Access Compliance Report Public Rights-of-Way (Curb Ramps)

Main Street: DOWNING_ST		Cross Street: MARKHAM_LN		Location:	NW
ADA ID: RPAT211103103113	Ramp Type: Type 4 - Parallel	Initial Pass/Fail: Fail	Overall Compliance: No	Severity Score:	2
Codes/Mitigation Info/Possible Solution			Field Measurements/Component Compliance

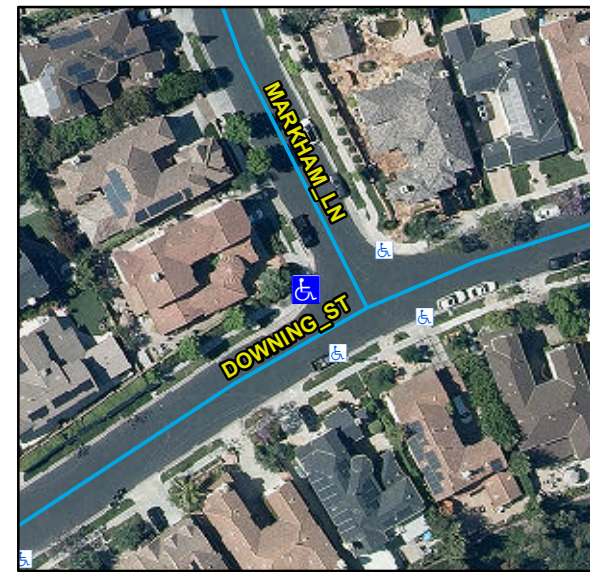
R204.3, R304.5.3, STD 1115

Remove & Replace Curb Ramp With Two New Directional Ramps or Equivalent.
